Access Compliance Report

Public Rights-of-Way

(Curb Ramps)

Intersection ID: 11824	Main Street: W_8TH_ST	Cross Street: N_CHURCH_ST	Location: N
ADA ID: 4C1AE6046AD1	Ramp Type: Perp	Initial Pass/Fail: Fail	Overall Compliance: No
		Severity Score: 12.5

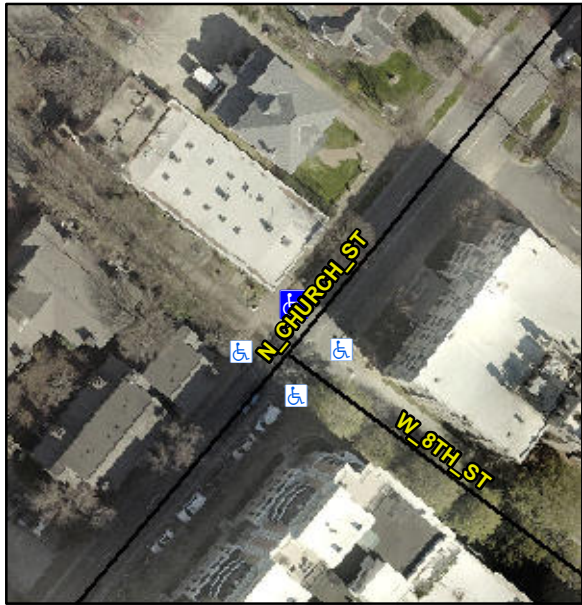
Codes/Mitigation Info/Possible Solution			Field Measurements/Component Compliance					
	Possible Solutions:		Compliance	Description	Data	Compliance	Description	Data
	Remove & Replace Entire Ramp.		N/A	Ramp Length (in)	61.0	No	Ramp Slope (%)	11.6
			Yes	Ramp Width (in)	48.0	Yes	Ramp XSlope (%)	1.5
			N/A	Flare Type LT	N/A	N/A	Flare Type RT	N/A
			N/A	Flare Slope LT (%)	N/A	N/A	Flare Slope RT (%)	N/A
			N/A	Flare Traversable LT?	N/A	N/A	Flare Traversable RT?	N/A
			N/A	Landing Length (in)	N/A	N/A	DWS Provided?	N/A
			N/A	Landing Width (in)	N/A	N/A	DWS Contrast?	N/A
			N/A	Landing Slope (%)	N/A	N/A	DWS Length (in)	N/A
			N/A	Landing X Slope (%)	N/A	N/A	DWS Full Width?	N/A
Surveyor Notes:		N/A	N/A	Landing Curb? (Y/N)	N/A	N/A	DWS Offset (in)	N/A
PROW/ADA:		Not Found, R304.2.2	N/A	Shared Landing?	N/A			
			N/A	Gutter Ponding?	N/A	N/A	Gutter Slope (%)	N/A
			N/A	Gutter Lip Ht (in)	N/A	N/A	Gutter X Slope (%)	N/A

N/A	Painted X Walk1?	No	N/A	Painted X Walk2?	N/A
				X Walk 1 Direction	To SE		X Walk 2 Direction	N/A
			N/A	X Walk 1 Width (in)	N/A	N/A	X Walk 2 Width (in)	N/A
				X Walk 1 Slope (%)	8.2		X Walk 2 Slope (%)	N/A
				X Walk 1 X Slope (%)	12.5		X Walk 2 X Slope (%)	N/A
			N/A	Ramp inside XWalk1?	N/A	N/A	Ramp inside XWalk2?	N/A
				Road Slope (%)	N/A	N/A	Clear Space?	N/A
				Road X Slope (%)	N/A	N/A	Clear Space to XWalk (in)	N/A
			N/A	Any Obstructions?	N/A	N/A	Storm Grate/Utility Hazard?	N/A
				Obstruction Type			Storm Grate/Utility Type	
					N/A			N/A
						Yes	Surface Condition? (G/P)	Good
Street 1 Name		N CHURCH ST						
Stop Condition-Street 2		None						
Street 2 Name		N/A						
Stop Condition-Street 1		N/A						
Total Cost:		\$ 1850.00
